February 1, 2002

HSA-10/B-95

In his January 14 letter to Mr. Richard Powers of my staff, Mr. Don Johnson requested formal Federal Highway Administration acceptance of a new guardrail post (called the O-Post) as an alternative to a standard W150 x 13 steel post for use with w-beam guardrail and asked that our response be sent to you. To support his request, he also provided a copy of a Southwest Research Institute test report dated January 2002, entitled "Full-Scale Crash Evaluation of a 12-Gauge W-Beam G4-1S Guardrail System with O-Posts Used as Line Posts" and copies of the crash test videotape.

O Post Cross-Section

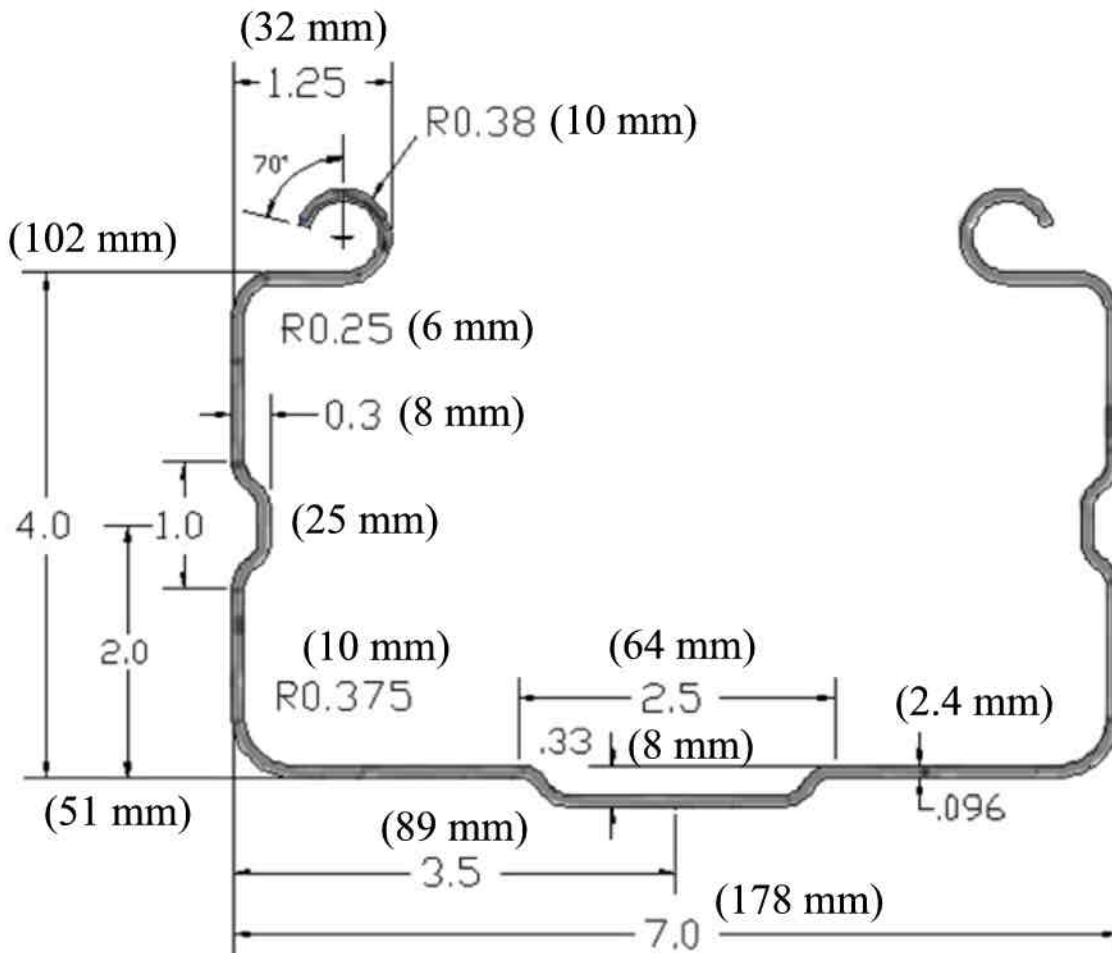
Based on the information you provided, I agree that the O-Post may be considered acceptable for use on the National Highway System as a substitute for the standard steel post currently used in the modified G4(1S) barrier system when such use is requested by the contracting highway agency. It must be used with a wood or

plastic offset block and oriented as tested with the open side of the post facing the downstream end of the barrier installation. Please note that this acceptance is only for the use of these posts in the barrier proper. They cannot be used in any of the guardrail terminals that require weakened or breakaway posts unless specifically tested for that application. Please note also that this acceptance is based on the reported crash performance of your posts and is not meant to address their installation, maintenance or repair characteristics. Since your post is a proprietary design, the provisions of Section 635.411 (Material or product selection) of Title 23, Code of Federal Regulations apply.
